GROUP	MODEL
CLI	2016-2020MY Optima (JFa)
NUMBER	DATE
057	October 2024

TECHNICAL SERVICE BULLETIN

BLOWER MOTOR FUSE RELOCATION

This bulletin provides the procedure to relocate the Heating, Ventilation, and Air Conditioning (HVAC) blower motor 40-ampere fuse on some 2016-2020MY Optima (JFa) vehicles produced from August 28, 2015 through June 23, 2020 which may experience an inoperative blower motor due to a blown multi-fuse at position #3. The HVAC system provides cooling and heating to help maintain a comfortable environment inside the vehicle cabin. The blower motor provides primary airflow for the HVAC system. Extended use of the HVAC system at high fan speeds may cause damage to the multi-fuse terminals for the HVAC blower motor circuit, which can cause the blower motor to become inoperative, resulting in reduced heat and air conditioning. Follow the procedure outlined in this publication to relocate the Heating, Ventilation, and Air Conditioning (HVAC) blower motor 40-ampere fuse to another circuit within the multi-fuse which has an increased terminal width on the applicable vehicle.

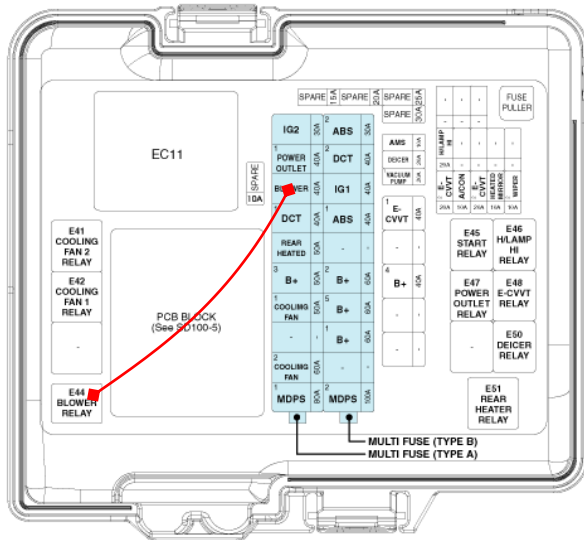
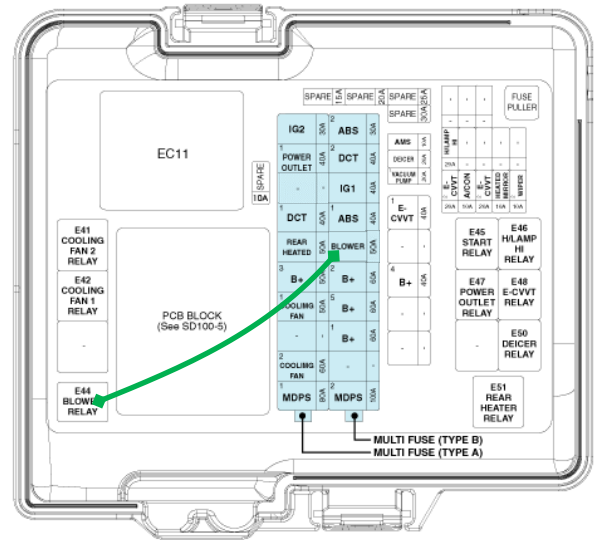
18a. Insert the other end of the new wire into the multi-fuse (M) #5 position on the junction box, as shown.

Note: Ensure that the new wire is secured behind the fabric tape.

BEFORE

AFTER
